UPDATE CHANGE NOTIFICATION # 16796BApple Corporation

TITLE: Request for approval to use an alternate production site for EFC4618R-TR (APN: 376S0976) (Update Notification to FPCN16796)

AFFECTED CHANGE CATEGORY(S): Transfer of Product to Alternate Site (BGA process)

Bump height

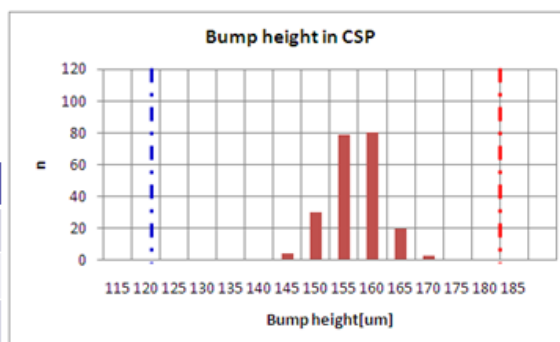
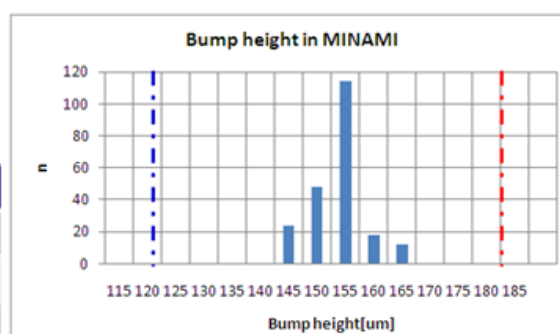
Height [um]
Ave.	154.6
MAX	167.0
MIN.	142.5

Height [um]
Ave.	151.4
MAX	161.7
MIN.	143.4

Bump strength

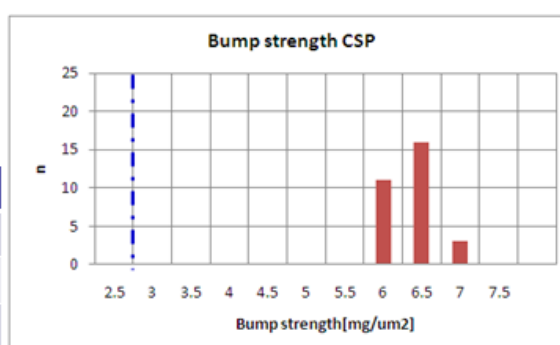
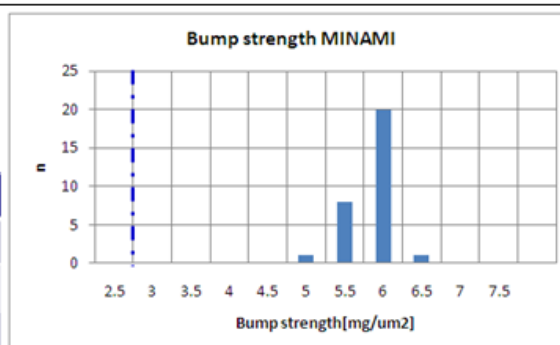
strength [mg/um2]
Ave.	6.140
MAX	6.775
MIN.	5.691

strength [mg/um2]
Ave.	5.602
MAX	6.327
MIN.	4.653

4) Solder test information (10pcs per lot for 3 lots) on parts from CSP.

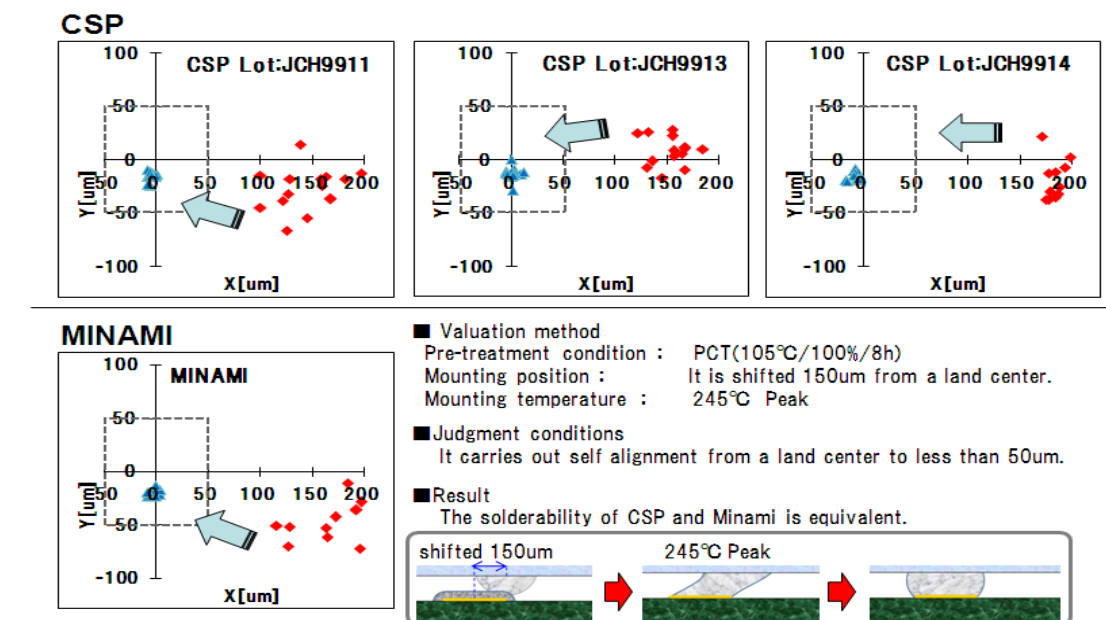
Provide Solder test (Self alignment evaluation)
